REPORT: 68 Burton Street For consideration: June 16, 2021

STAFF REPORT

PROJECT: 68 Burton Street

Front Façade from Burton Street - Google Street View Image October 2020

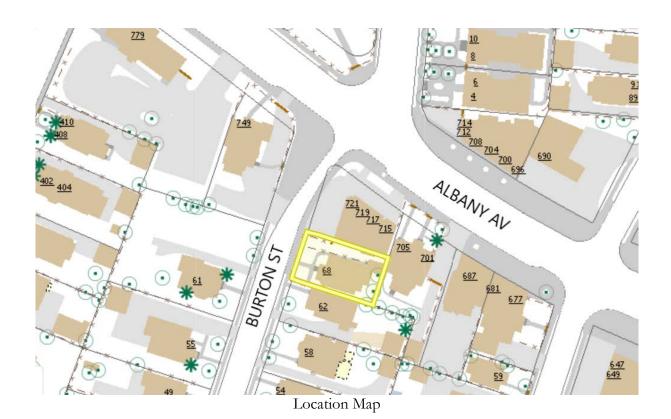
Current Conditions: The applicant has replaced existing wood windows with vinyl windows, but the trim work/details are still extant. The siding is largely synthetic.
